# Detailed Planned Development

For the development of a hotel at 1709 North Farwell Avenue

February 24, 2023

Milwaukee Water Works (MWW) Review Comments for Brady-Farwell Hotel at 1709-1723 N. Farwell Ave.

FIGURE - 23 B

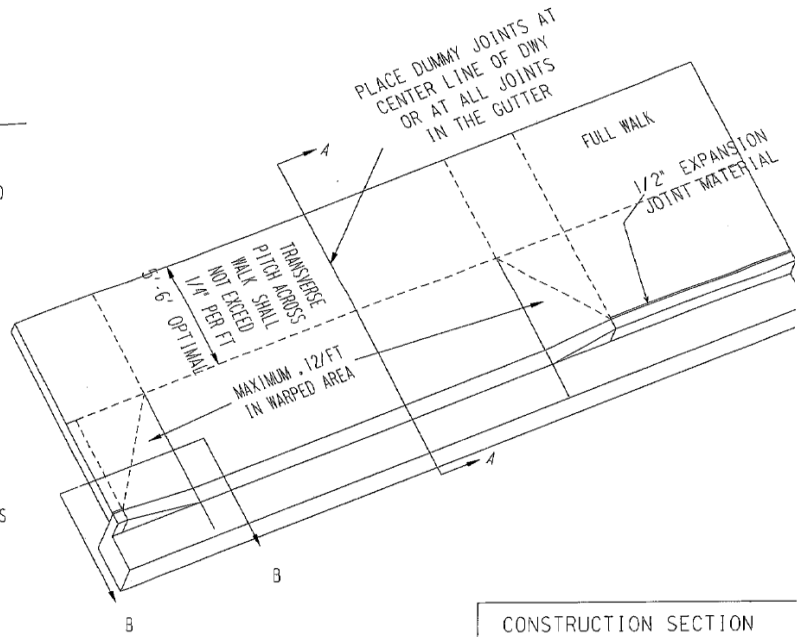
Below please find a revised detail for a modified depressed driveway. Please note that the project design must provide a through sidewalk with a minimum width of 4 feet and a cross slope not to exceed 2%. Ideally, a through sidewalk that is at least 5 wide is preferred at driveway approaches.
